OULTON PARISH COUNCIL: PINS Ref: 20022619

Re: NORFOLK BOREAS: Oulton Parish Council's submission at Deadline 2

Oulton Parish Council's response to Written Questions for Norfolk Boreas Scenarios 1 & 2 at Deadline 2

Hornsea Project Three

B1149 road works Norfolk Boreas OTMP appendices (Version 2) deadline 1

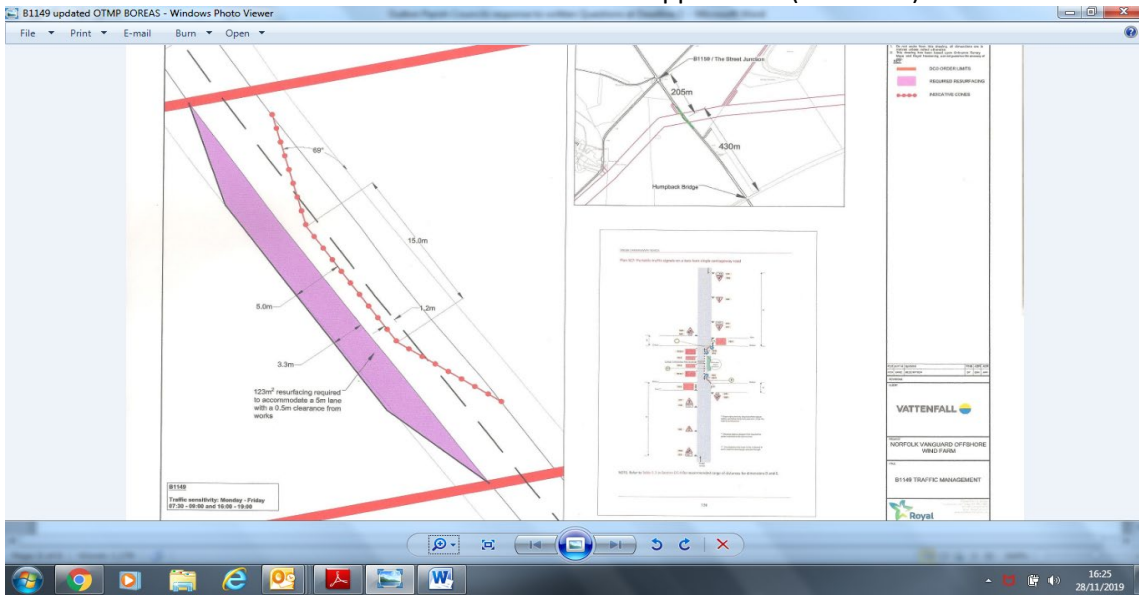
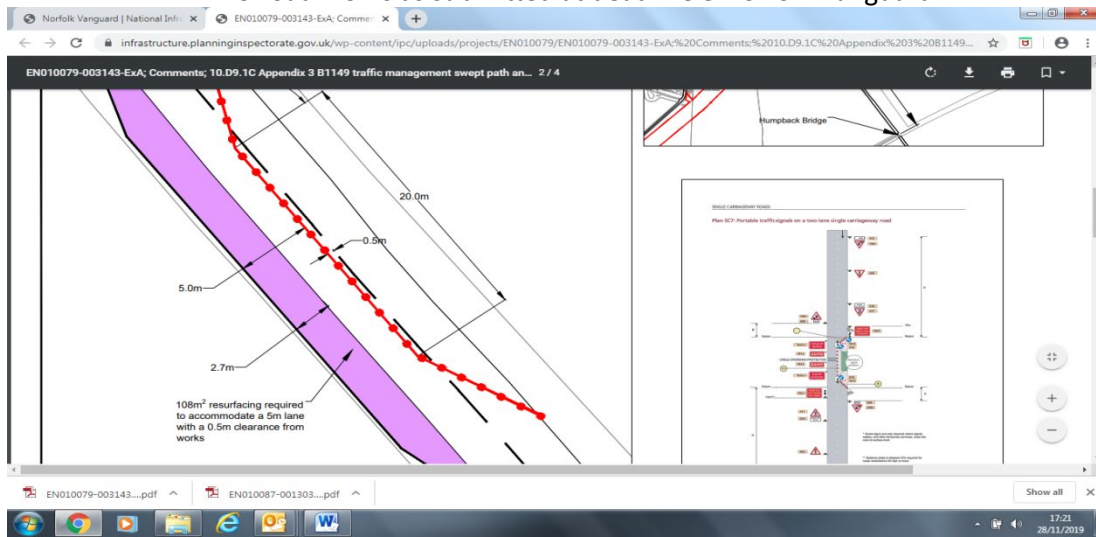
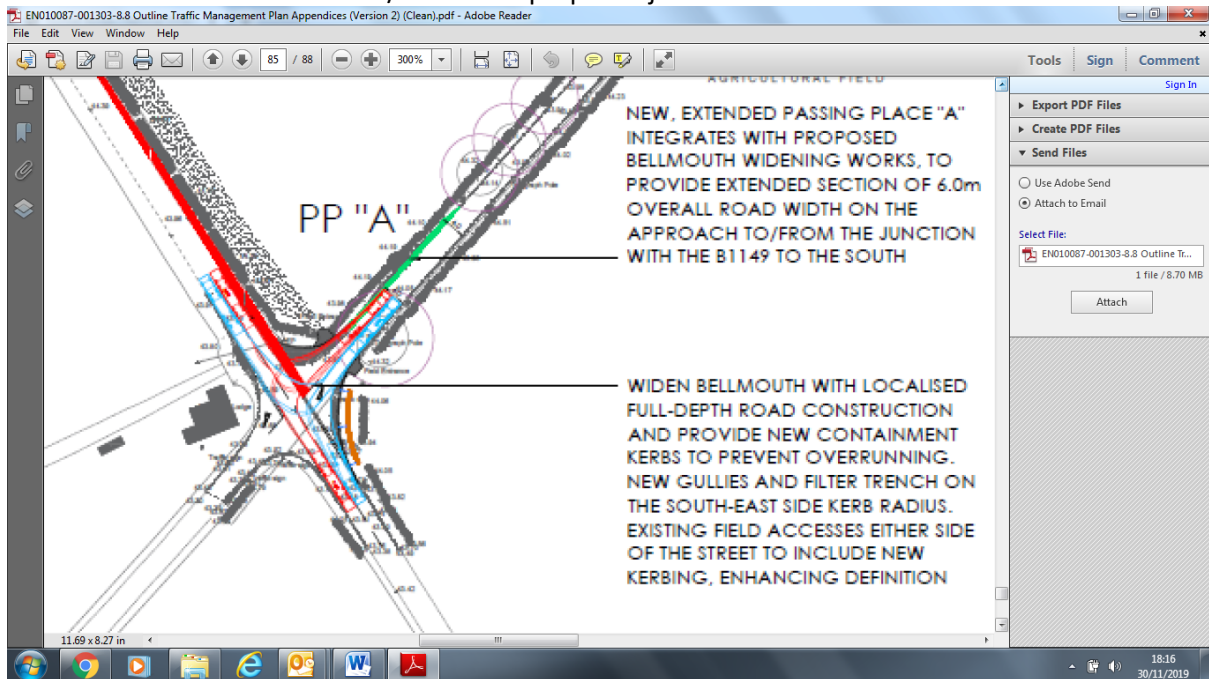
It is noted that there have been changes to the proposed road works to the trenching on B1149. These changes appear in the Applicant's Outline Traffic Management Plan appendices (version 2) submitted at Deadline 1. There are changes to the width and length and M3 required for resurfacing the area; these differ from the plans as submitted at Deadline 8 for the Norfolk Vanguard DCO.

OPC queries whether this would mean the need to use more of the verge to produce the increased road width, and if so, is this land secured within the DCO?

OPC also queries whether these revised plans have been accepted by Norfolk County Council, given their negative response at deadline 9 of the Norfolk Vanguard examination?

Is the separation between the B1149 junction with The Street and the proposed road works (205m) sufficient? Has the Applicant also taken into consideration the cumulative impact of Norfolk Boreas Scenario 2 with Equinor's Dudgeon and Sheringham Extension project, if they were to be constructed during the same time period? The cable corridor for the latter will pass extremely close to this trenched crossing.

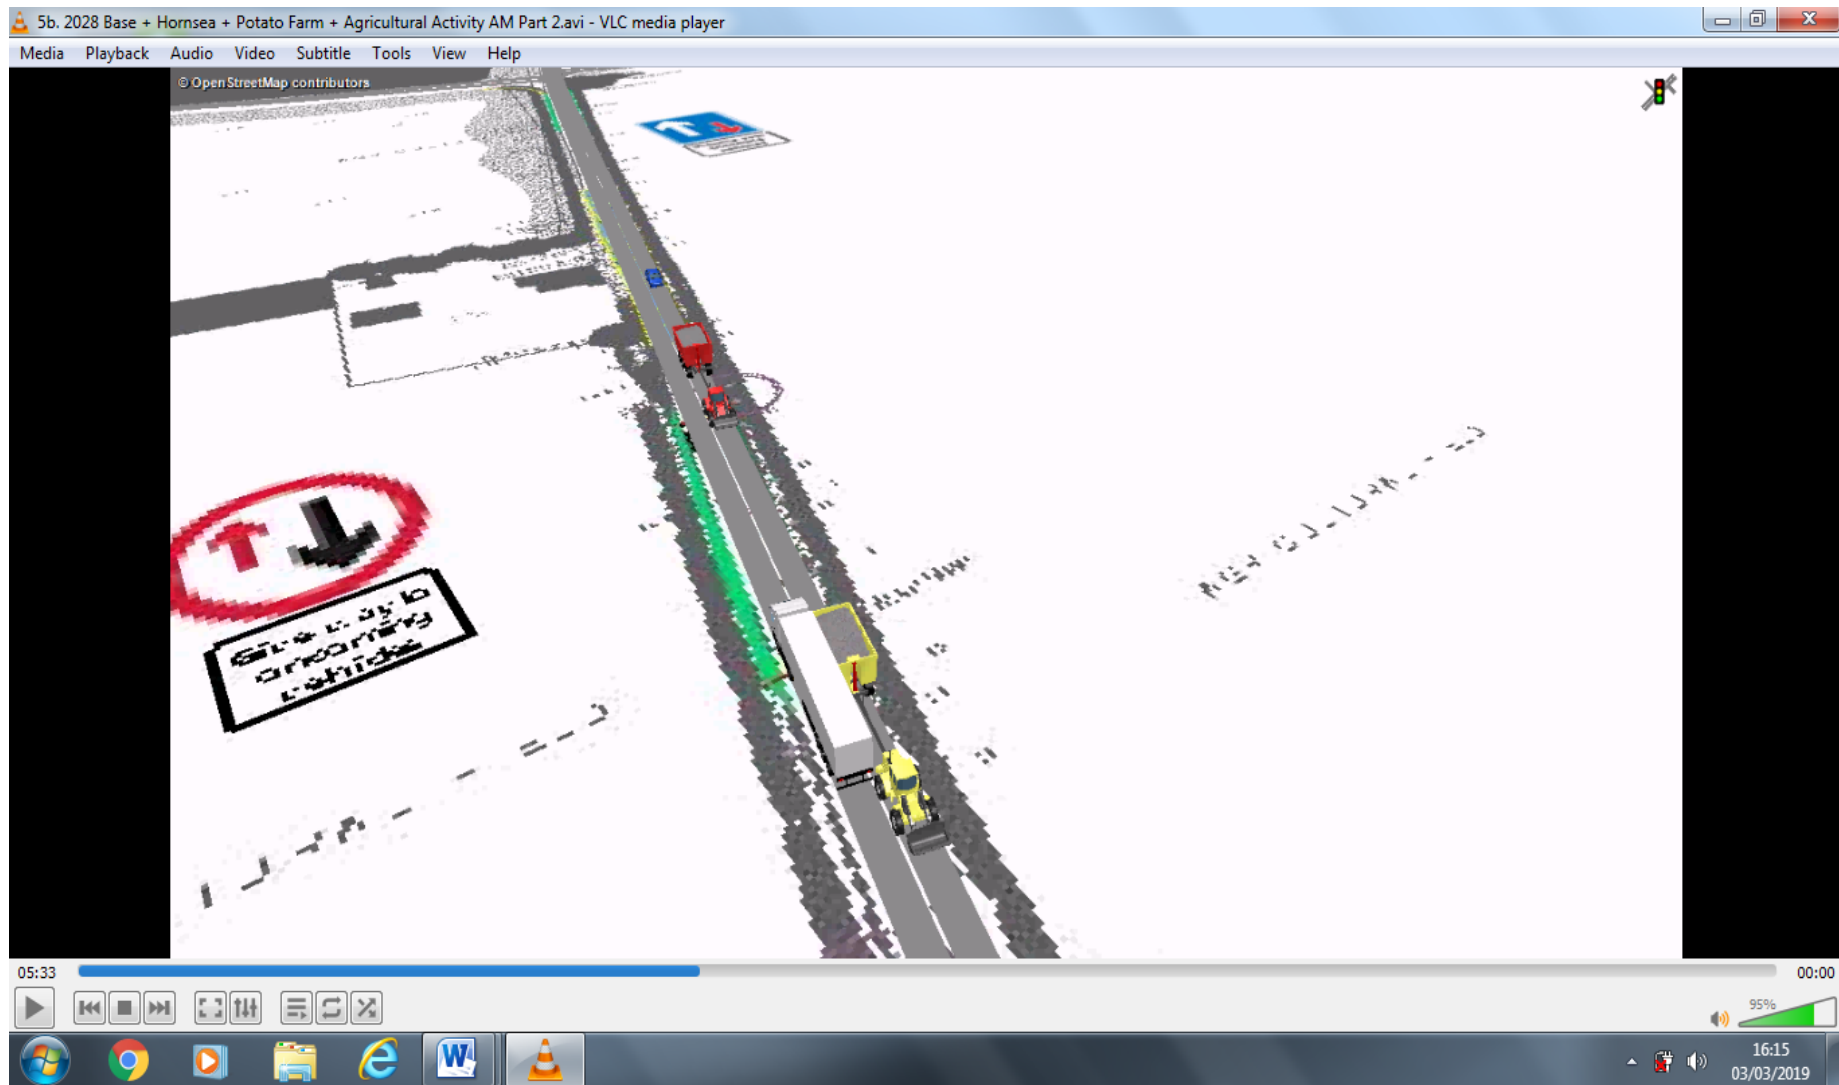
*Priority signs at the hump next to the Railway Gatehouse not working: it would not be possible for two tractor/trailers or HGVs to pass at this point. The road width at this point is planned to be the same as currently.

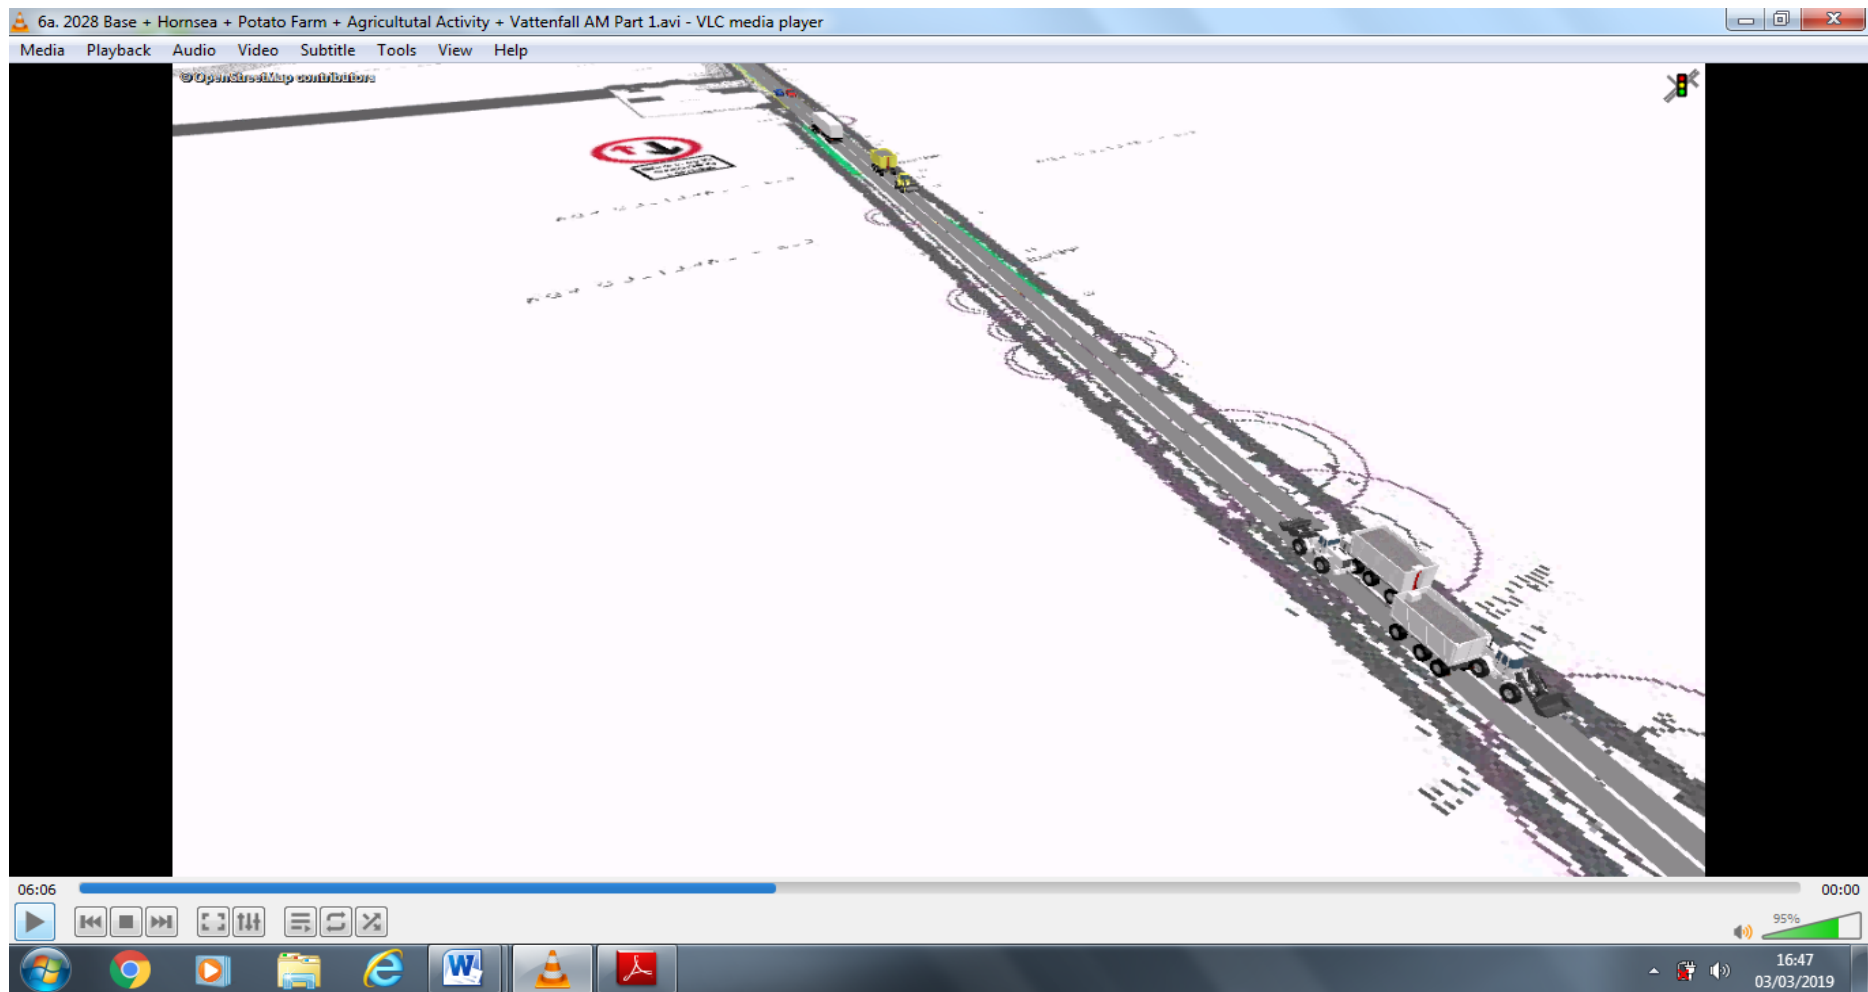
Data input error: one HGV and one tractor/trailer passing each other without use of passing place. This is impossible - the road is too narrow.

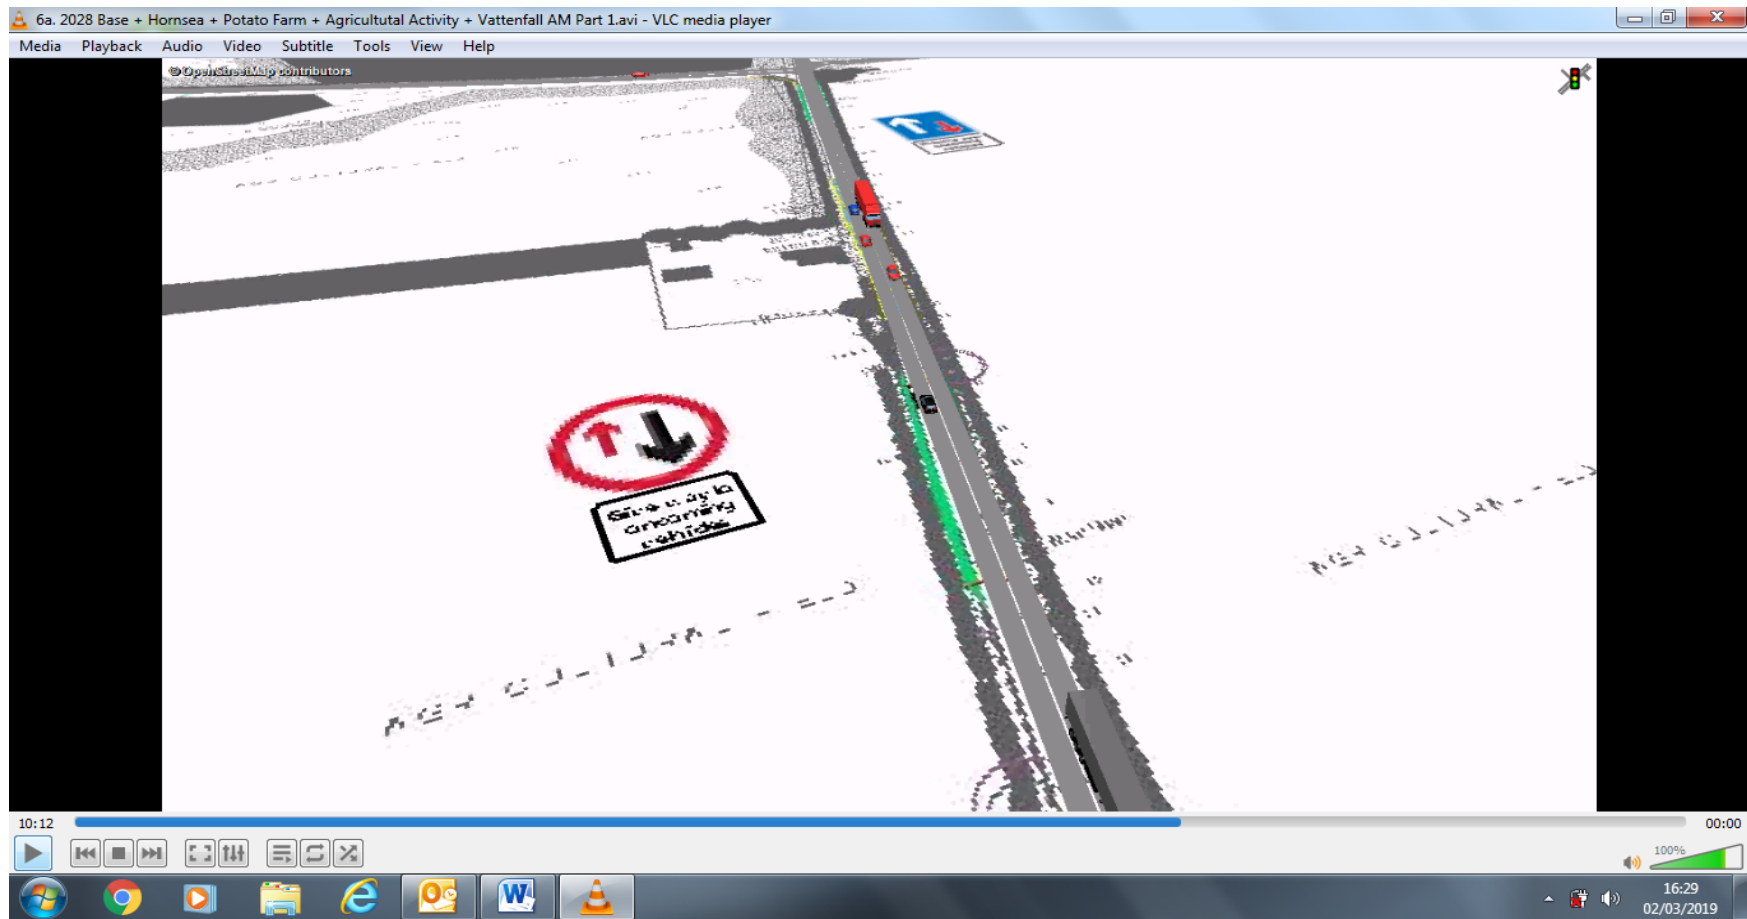
Two tractor trailers passing outside of passing places – this is impossible.
[6a 2028 Base + Hornsea + potato Farm + agricultural activity + Vattenfall AM part 1.]

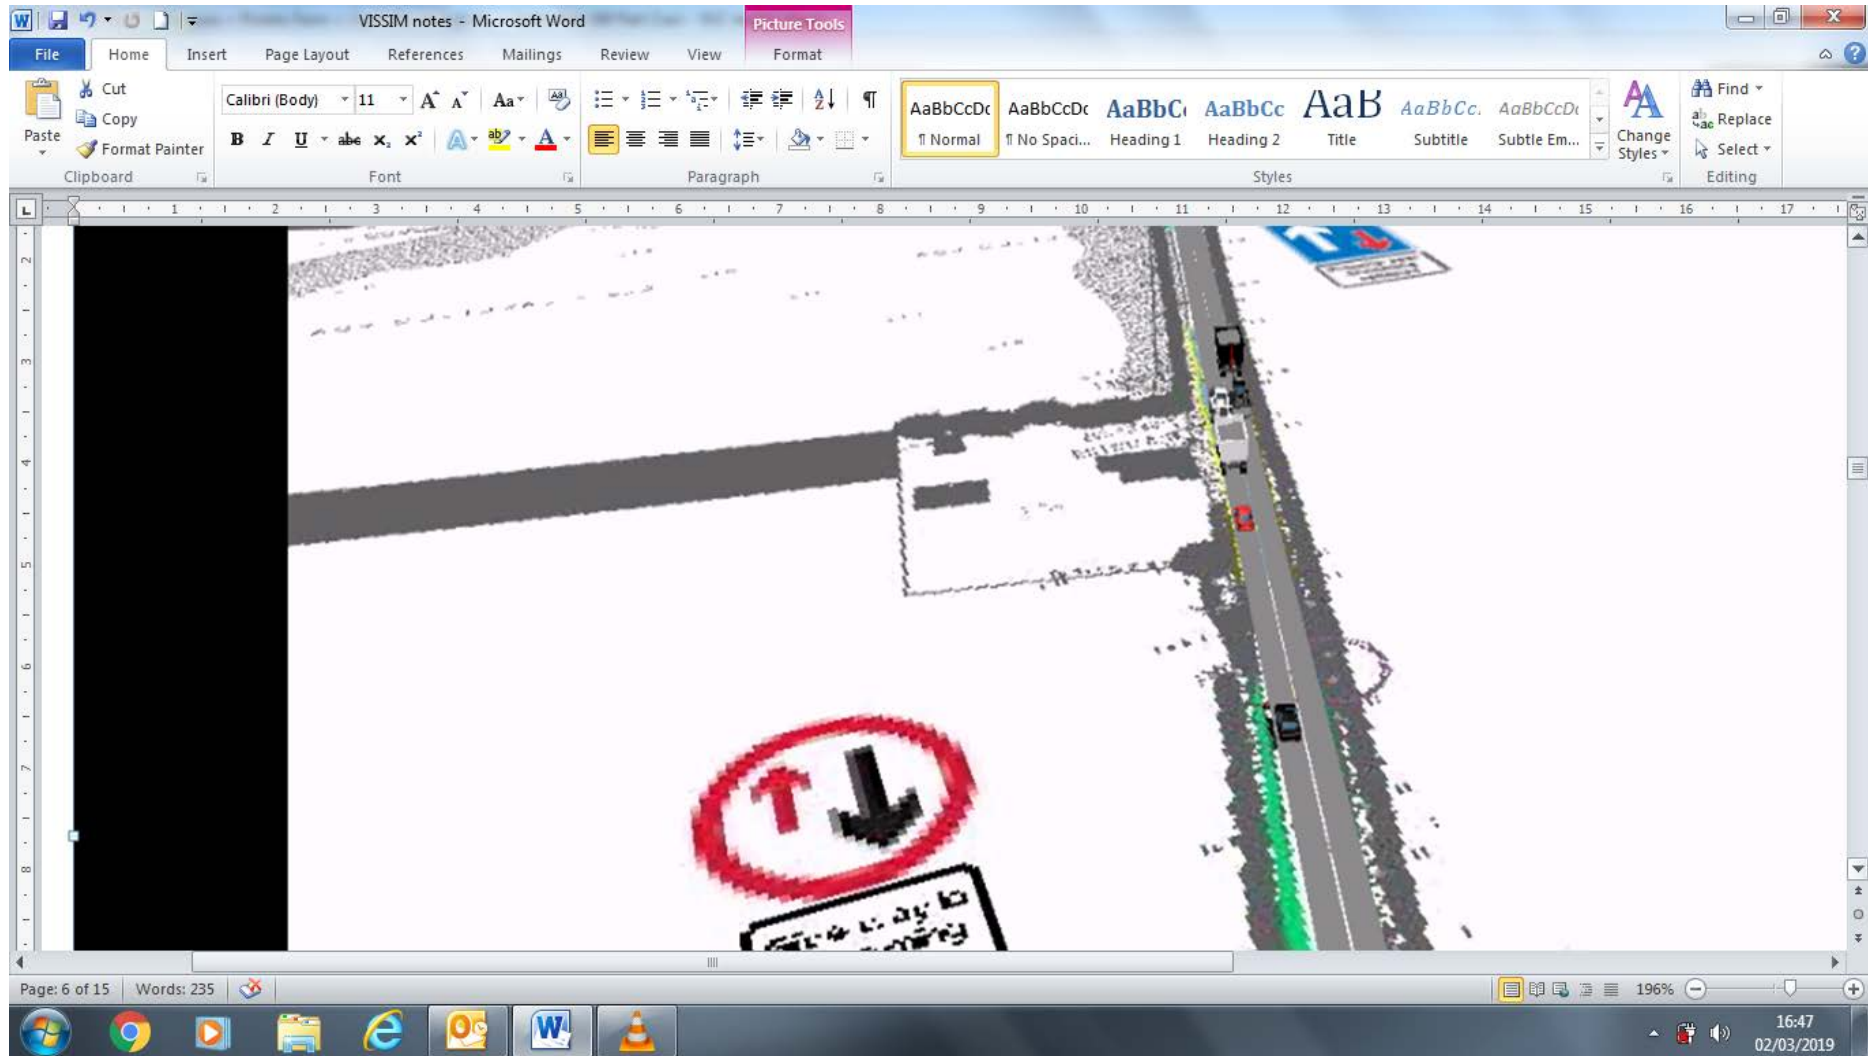
Priority signs not working at the hump: it is impossible for an HGV and a car to pass at that location.
